RE: Partial Withdrawal and Partial Reaffirmation of a UIC Program Revision establishing an Aquifer Exemption for uranium mining in a portion of the Goliad Aquifer near Ander, Texas in Goliad County

# Statement of Basis

## EPA Reconsideration of Goliad Aquifer Exemption

June 2014

**Sand A Exemption approximate boundary\***

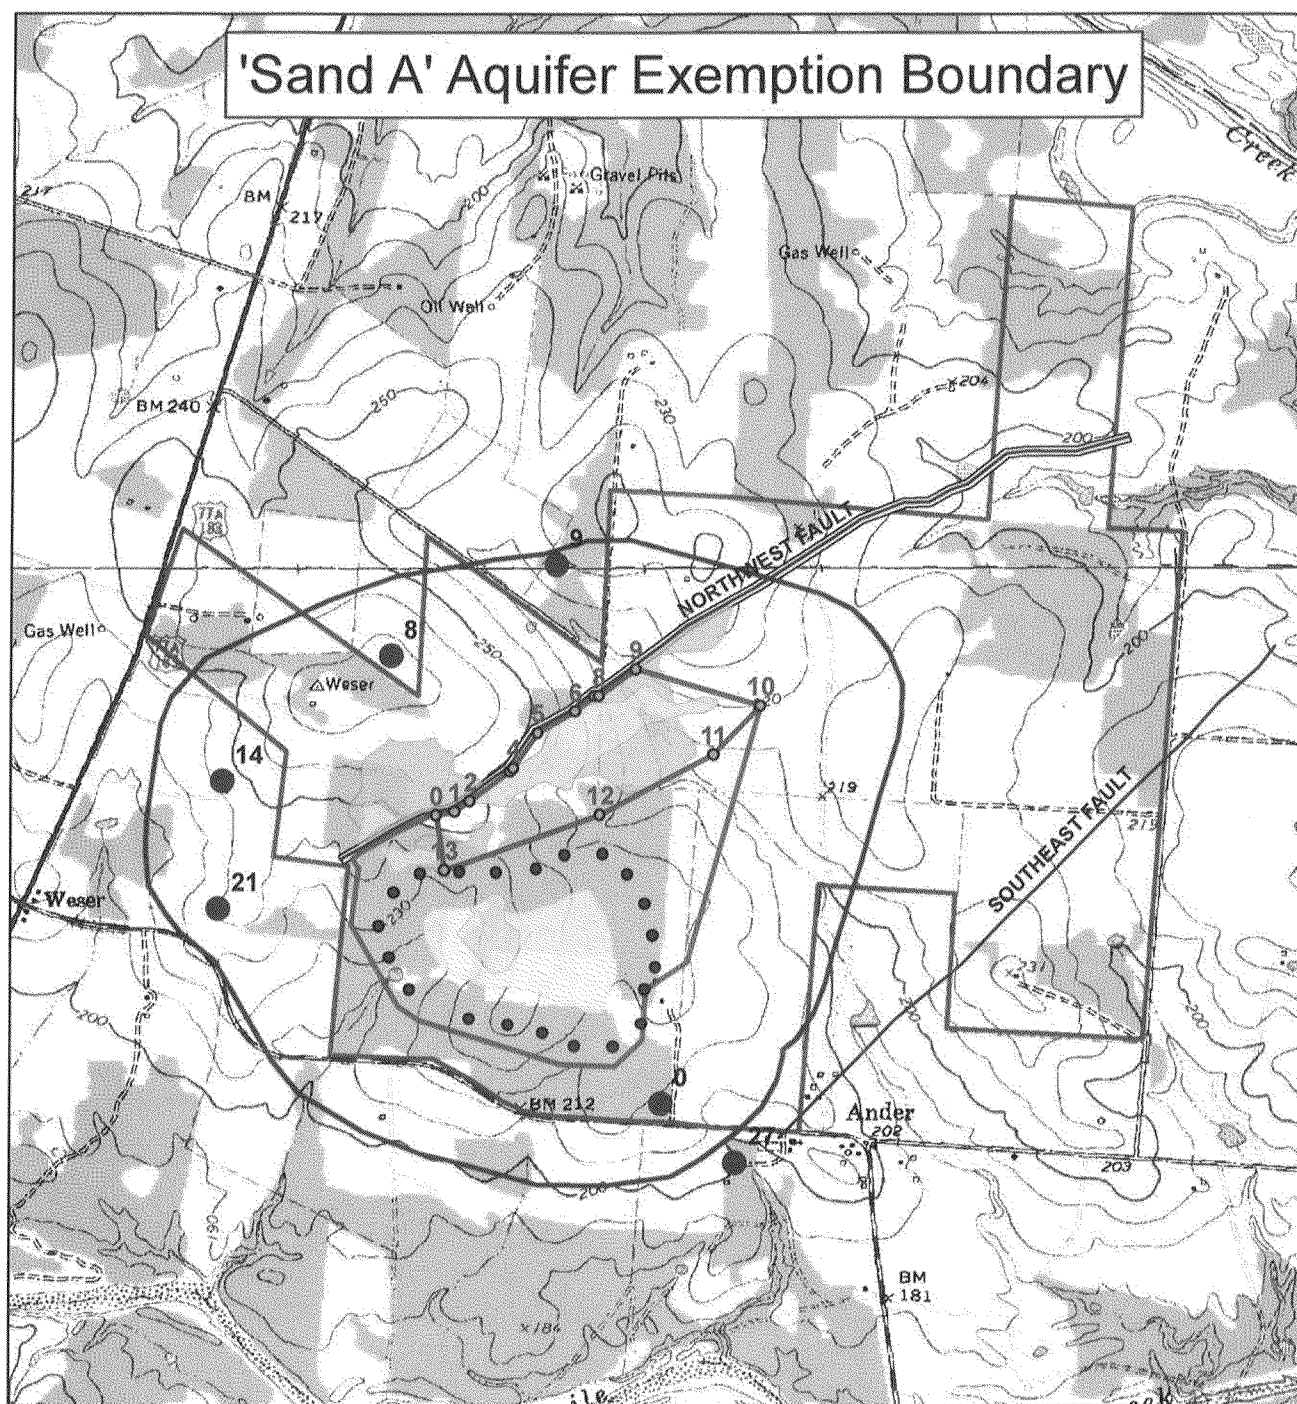
With respect to that portion of the exempted area north of the Northwest Fault, EPA concludes there is a significant lack of ground water elevation data in that area. EPA received only one Sand A water elevation data point (September 2008 data set); as a result, EPA could not make a definitive finding about possible recharge or the ground water flow direction in the area. Additionally, EPA shares the concerns presented on pages 2-3 in the Larry Dunbar report (Citation 9) suggesting the possibility of a recharge area that could significantly alter the local ground water flow direction on the north side of the Northwest Fault. In addition, of the four domestic wells of concern, only two have known depths and are considered to be completed in the Sand B. Without the necessary depth and flow data and given the evidence that it is a possible recharge area, EPA could not evaluate the capture zone of the wells in relation to the exemption area north of the Northwest Fault. As a result of insufficient technical data available to warrant reaffirming EPA's December 2012 approval in its entirety, EPA is withdrawing approval of the aquifer exemption for the area north of the Northwest Fault. The resulting modified area is shown and described in the attached maps and "Technical Exemption Area Derivation".

As discussed in the Statement of Basis for the June 2014 Goliad Aquifer exemption decision, the approved exemption area is only on the southeast side of NW fault. Due to the uncertainty of the exact fault location a conservative 50 foot buffer to the southeast was used to define the northern edge of the exemption area.
